**P03:**  
Changes made to previously approved proposal

Previous NMA Proposal submitted under application ref. 2020/1990/P & Listed Building Consent ref. 2020/1992/L

ISSUE	DATE	DRAWN	CHECKED	DESCRIPTION
<b>DRAWING TITLE</b>	GA PROPOSED DEMOLITIONS AND STRIP OUT BASEMENT LEVEL FLOOR PLAN			
<b>DRAWING NO.</b>	CTH-PUR-MP-B0-DR-A-91000			
<b>REVISION</b>	P03			
<b>SIZE &amp; SCALE</b>	A1L 1:200			
<b>DRAWING STATUS</b>	S4 - Planning

<b>CLIENT</b>	Lendlease	
<b>PROJECT</b>	Camden Town Hall	
<b>JOB NUMBER</b>	238664

**I BASEMENT FLOOR LEVEL PLAN PROPOSED DEMOLITIONS AND STRIP OUT**  
91000 1:200 @ A1

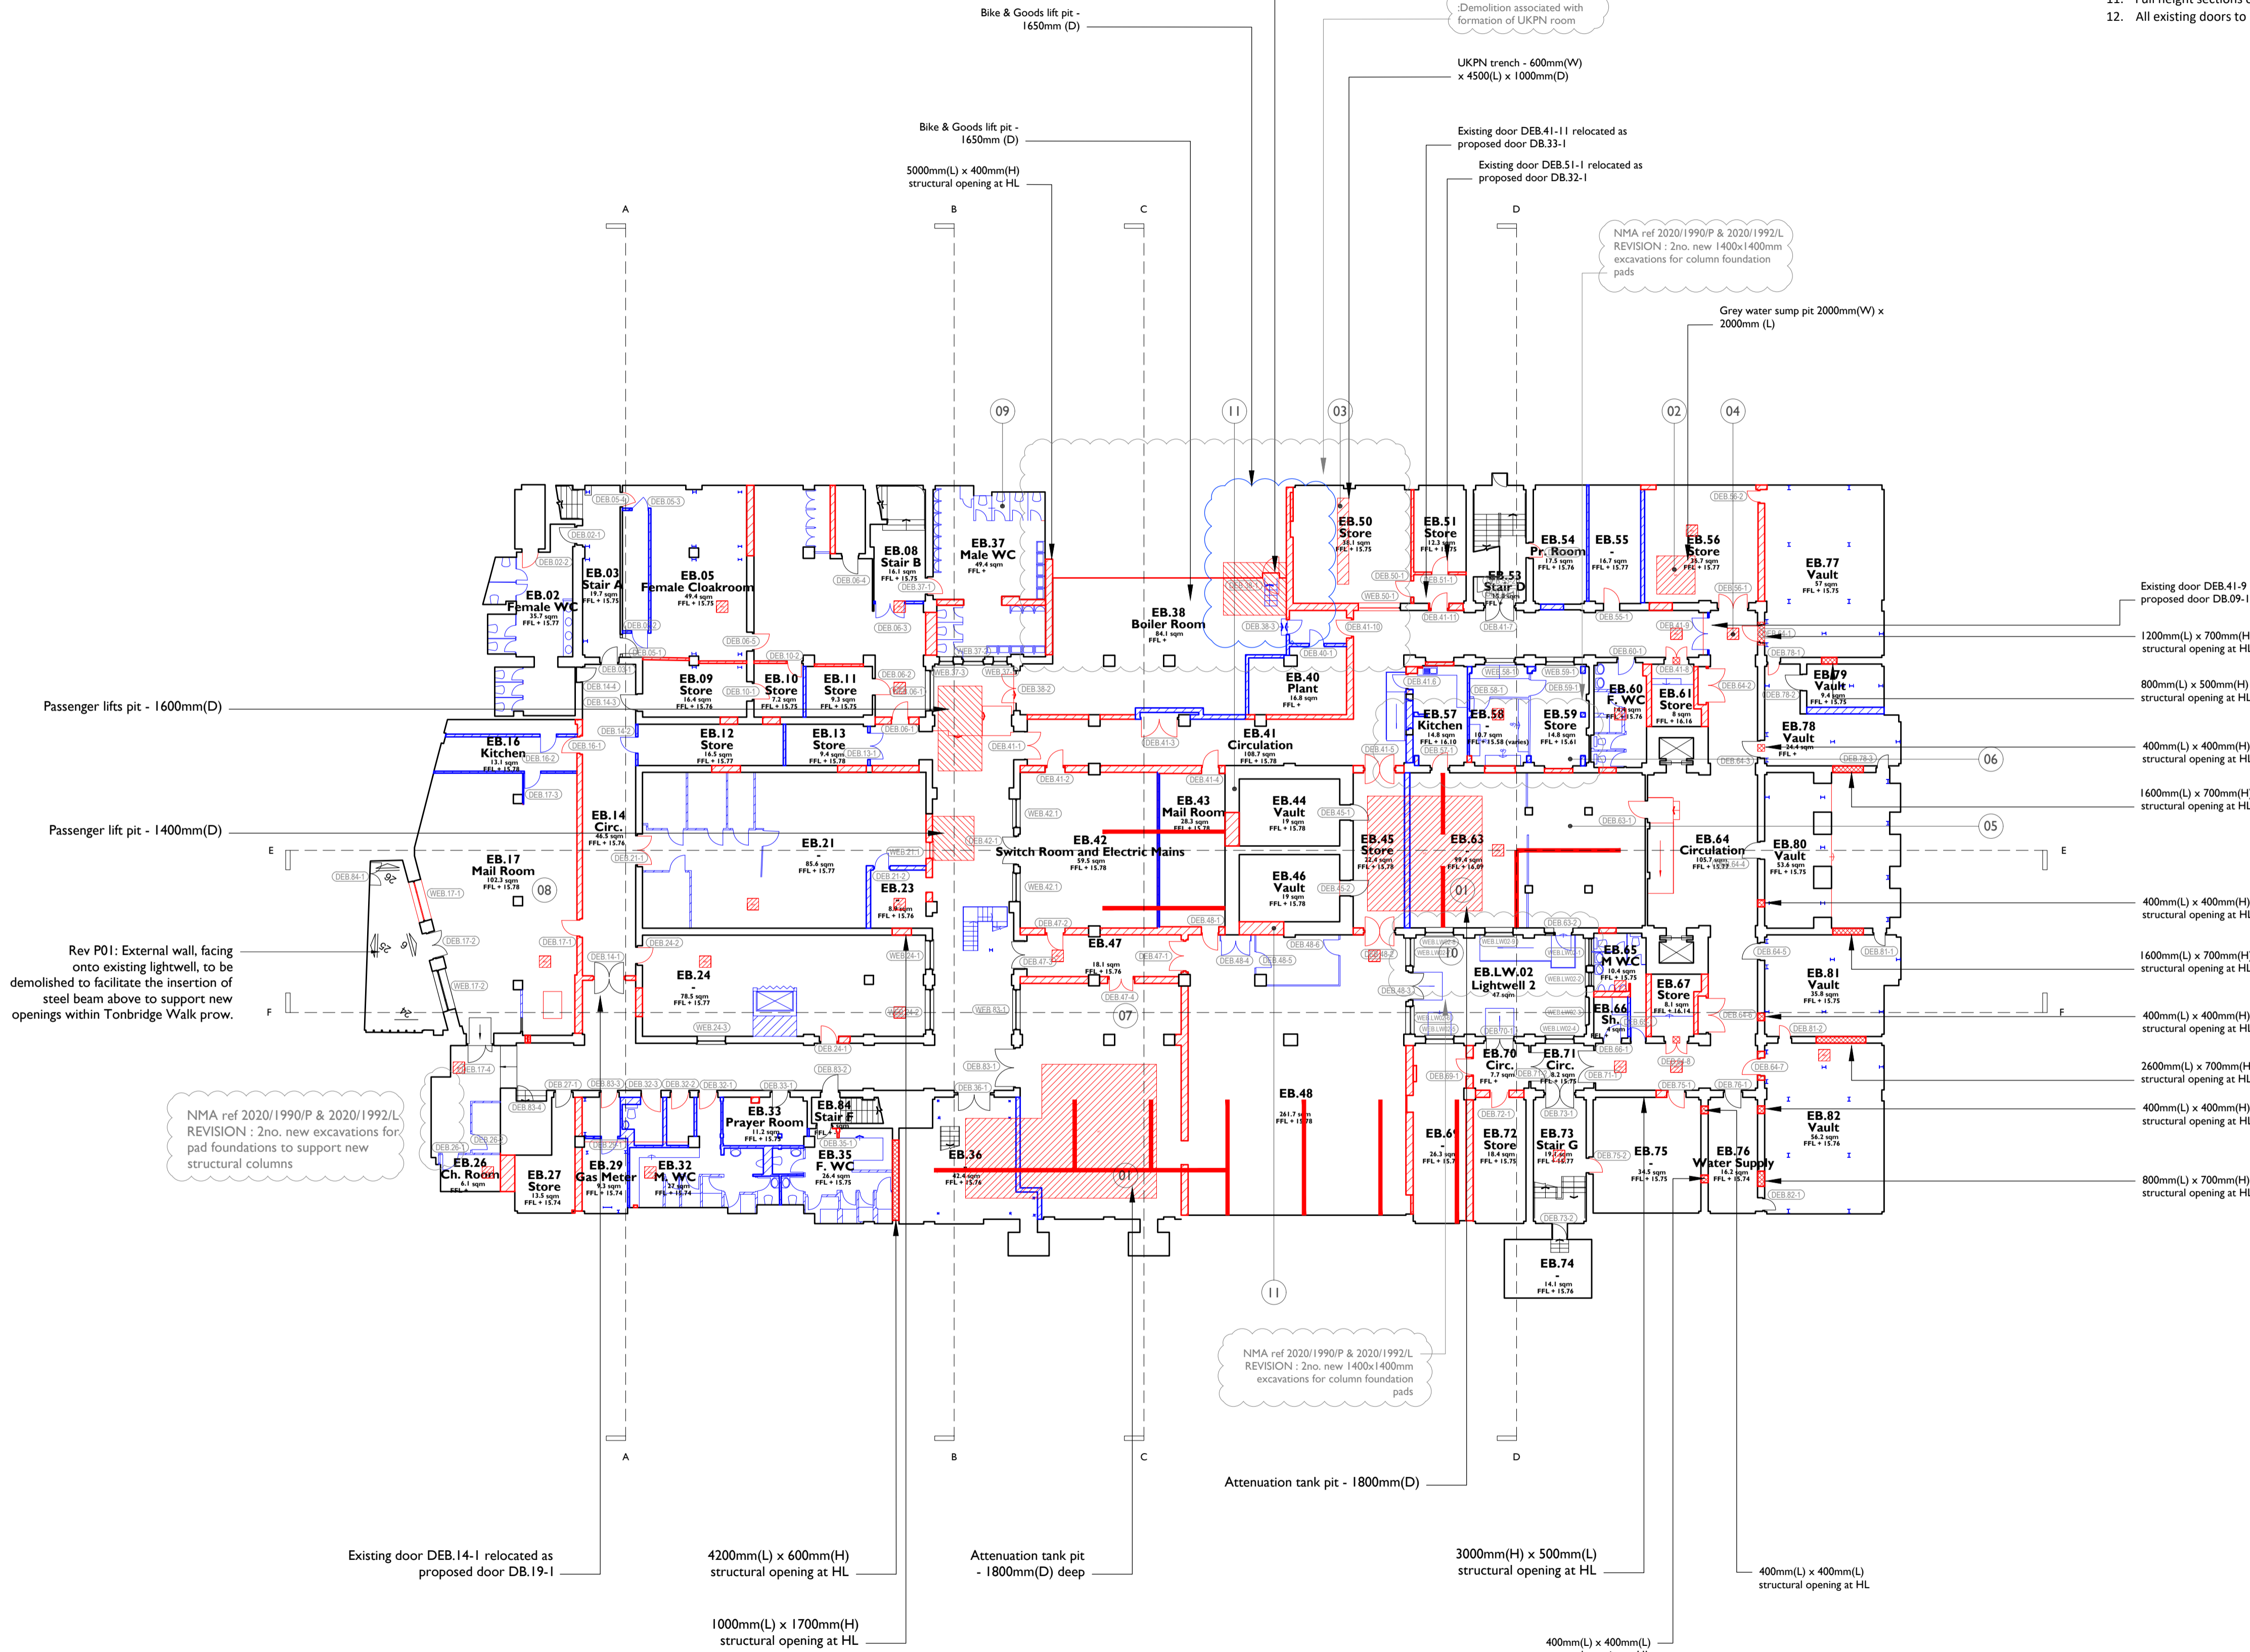
1. New slab structural opening for attenuation tanks.
2. New slab structural opening for sump pit (greywater harvesting tank).
3. New slab structural opening for transformers trench (UKPN).
4. New slab structural opening for PH manholes.
5. Raised screeded area to be lowered to original floor level to provide level access across basement floor.
6. WCs to the base of South West Lightwell to be stripped out.
7. Existing fabric removed to create an open plan office space. Downstands and columns retained. All suspended ceiling and proprietary fixings stripped out.
8. Existing fabric removed for building services/ support spaces. All suspended ceiling and proprietary fixings stripped out.
9. Existing WCs stripped out.
10. Existing ramps removed.
11. Full height sections of walls to existing vaults.
12. All existing doors to lightwells to be stripped out.
